1 Q. **Re: IN-NLH-032**

Chart 1: Generation CAPEX - Growth vs. Sustaining

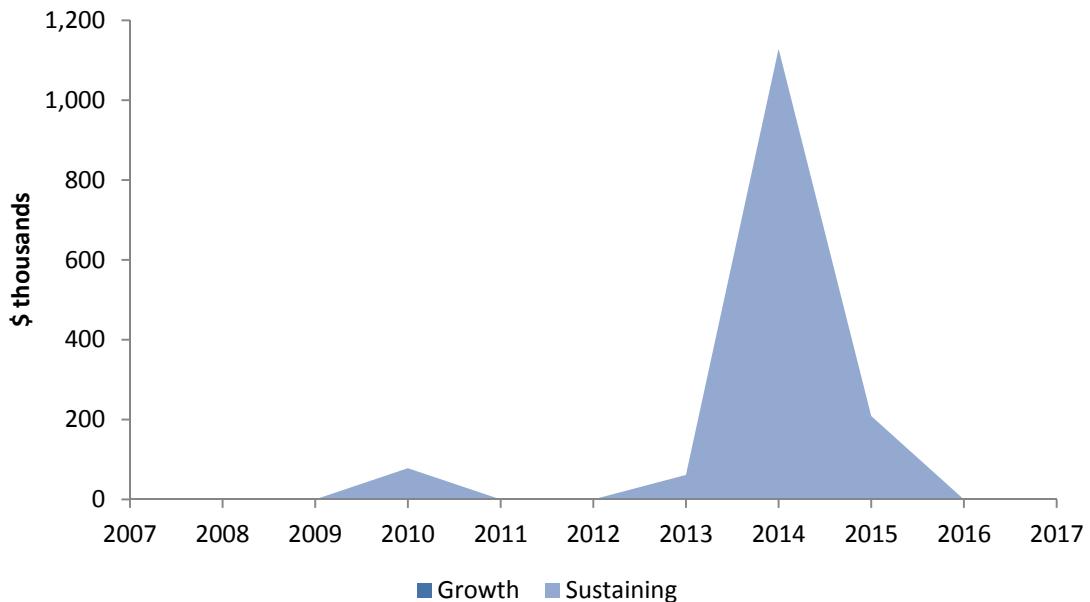
5 Please present charts similar to Charts 1-4, including only those projects that
6 concern the Labrador Interconnected System.

12 A Please see Charts 1 to 3 below which show capital expenditures and forecasts for
13 2007 to 2017 at the time of evidence preparation by generation, distribution and
14 other with growth and sustaining expenditures segregated pertaining to the
15 Labrador Interconnected System. Please note that these charts exclude capital
16 projects such as vehicle replacements, power transformer upgrades, and computer
17 replacements that could have components pertaining to the Labrador
18 Interconnected System. There were no capital expenditures by transmission assets
19 for the Labrador Interconnected System. As well, Hydro's GRA filing in July, 2013
20 did not include the new transmission line currently planned for Labrador West and
21 thus is not reflected in this response.
